RE: **13424 Cedarbrook Ave NE**
Grading and Drainage Plan
Engineer's Stamp Date: 9/24/18
Drainage File: F23D013

<div>ENGINEER'S SEAL</div> <div>DAVID SOULE NEW MEXICO REGISTERED PROFESSIONAL ENGINEER 14522</div> <div>9/24/18</div> <div>DAVID SOULE P.E. #14522</div>	13424 CEDARBROOK AVE.	DRAWN By DEM
	GRADING AND DRAINAGE PLAN	DATE 9-23-2018
	<div></div> <div>Rio Grande Engineering 1800 CENTRAL AVENUE SUITE 301 ALBUQUERQUE, NM 87108 (505) 872-0000</div>	SHEET # 1 OF 1 JOB # XXXXX

**RE: 13424 Cedarbrook Ave NE
Drainage file F23D013**

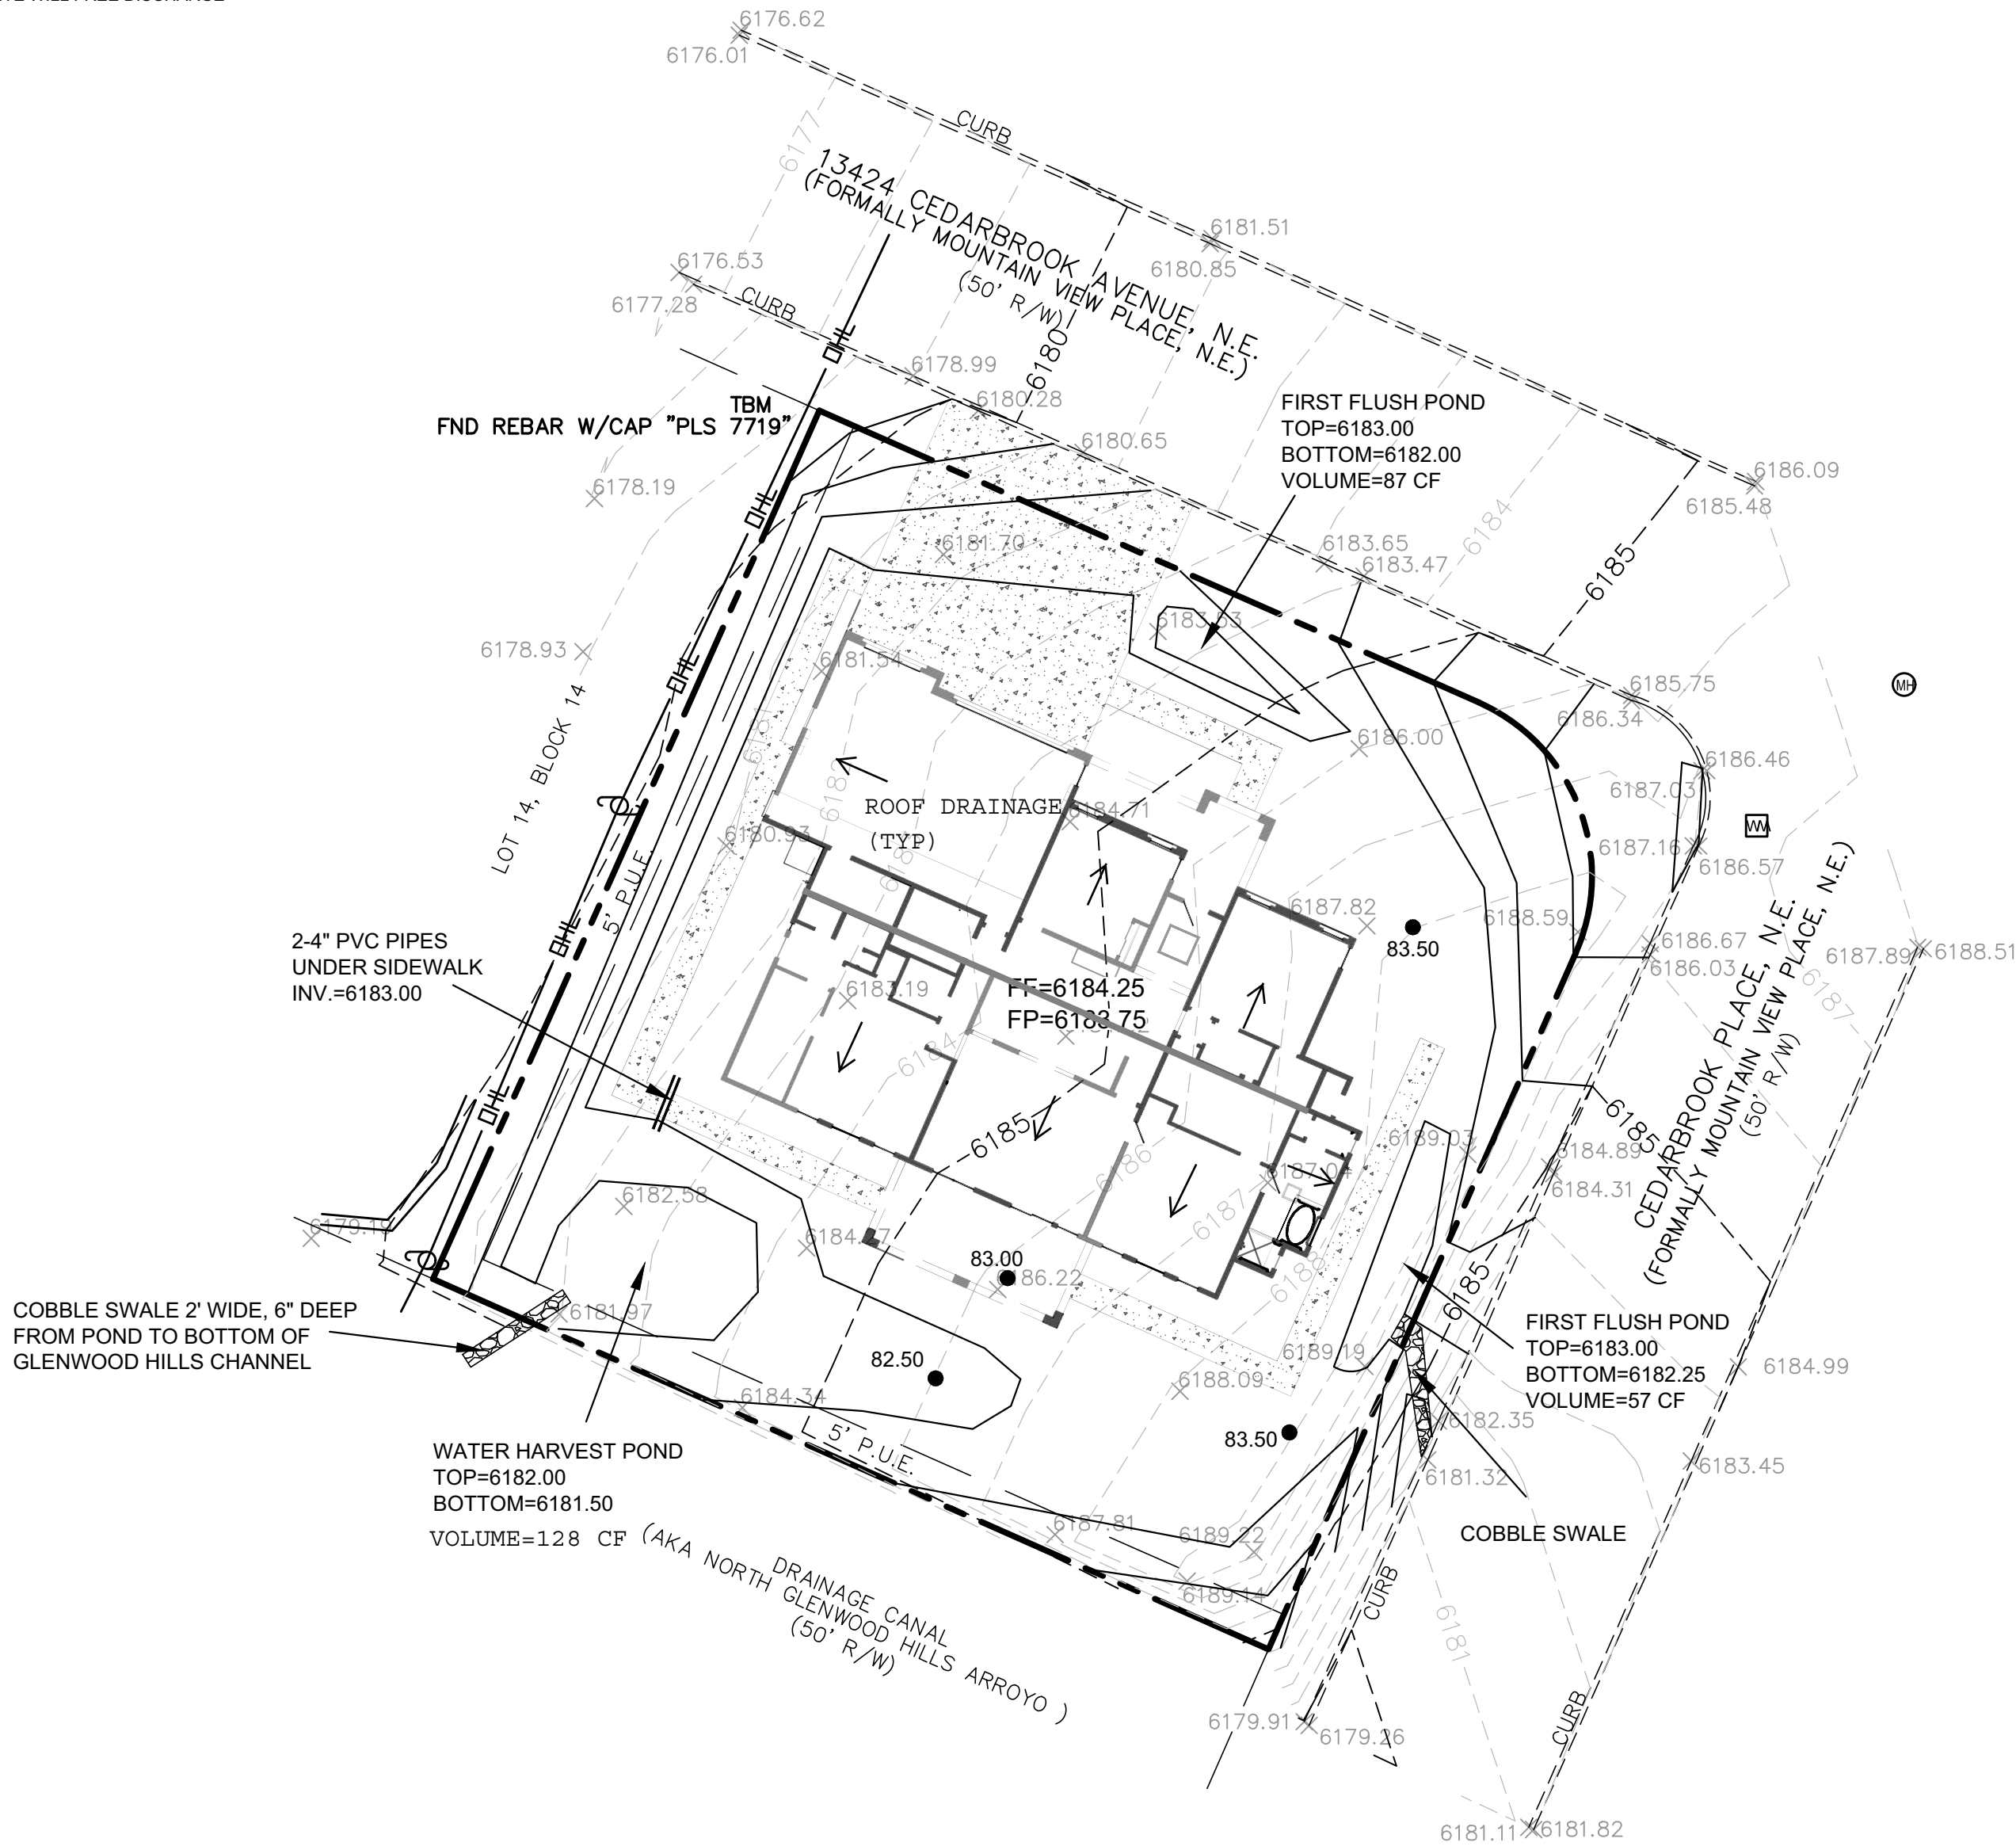
1. Please update the stamp date.
2. The 40-acres or less method is not reasonable for this watershed; provide subbasins and an AHYMO model or HEC-HMS model to determine Q_{100} .
3. Provide a profile of the arroyo, beginning at the upstream edge of Cedarbrook Place crossing. Include: bottom of arroyo, normal depth, critical depth, top of existing and proposed banks, the proposed building pad and freeboard.
4. Provide freeboard per DPM Ch22.C.4. Freeboard will need to be measured from the water surface on the road crossing to the top of the pad. If flows are calculated as supercritical; then the critical depth will need to be used as the controlling water surface.
5. Show the adjacent grades in N Glenwood Hills Arroyo; ensure that your grading ties-in at the ROW line.

1. Show the adjacent grades in N Glenwood Hills Arroyo; ensure that your grading ties-in at the ROW line. Do not lower the grade adjacent to the arroyo.
2. Label the proposed contours.
3. First flush is not required on single residences; the ponds may be removed if desired.
4. Because N Glenwood Hills Arroyo is an unnumbered A-zone; make a reasonable assumption as to the 100-yr water surface elevation at the upstream edge of this lot and ensure the pad is elevated above it (+1ft freeboard recommended).
5. Do not regrade the ROW along Cedarbrook Place; it's keeping the water in the arroyo.

1. The Topo did not extend into the arroyo. I have enclosed the city GIS 2' contours and a picture to show that the lot is significantly higher. The proposed grading on the site does not change the top grade at the drainage right of way line. As shown below the anticipated flow depth is 2.35' therefore the grading shown will not have impact on the arroyo.
2. We have added contour labels.
3. We try to incorporate LID where possible, we prefer to show the ponds and will be able to certify even if not constructed..
4. We have calculated the upland flow and utilized Manning's equation to determine the flow rate of 565 cfs will provide a maximum water surface elevation of 2.35'. The existing channel is 6' deep near our site
5. As shown from the estimated flow depth and area of re-grading, the grading will not impact the flow and will eliminate the need for retaining walls
